Staff Report

To: Salt Lake City Planning Commission
From: Rylee Hall, Principal Planner
rylee.hall@slcgov.com or 801-535-6308
Date: September 27th, 2023; Published September 21st, 2023
Re: PLNPCM2022-01062 (Design Review) & PLNPCM2023-00294 (Planned Development),
The Silos Phase 2

Design Review & Planned Development

North Elevation (facing 500 South)

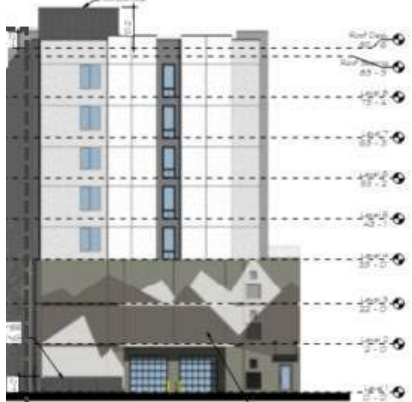
During the review process, planning staff identified concerns with the north and west elevations related to design standards that speak to building orientation and facades with detailing and glazing to facilitate pedestrian interest and interaction. In response, the applicant made the following revisions:

The north elevation originally included large expanses of blank wall on the first three levels and lacked pedestrian oriented elements. The revised design includes the addition of windows on the ground floor, material changes, and in lieu of a mural, an art installation utilizing metal mesh forming imagery of mountains to add texture and detailing to facilitate pedestrian interest on the second and third stories of the building. Staff suggested further revising the openings along the ground floor to have more of a hierarchy with the upper levels and to be more consistent with the solid to void ratio of the upper stories, but the applicant ultimately chose to move forward with the design as proposed.
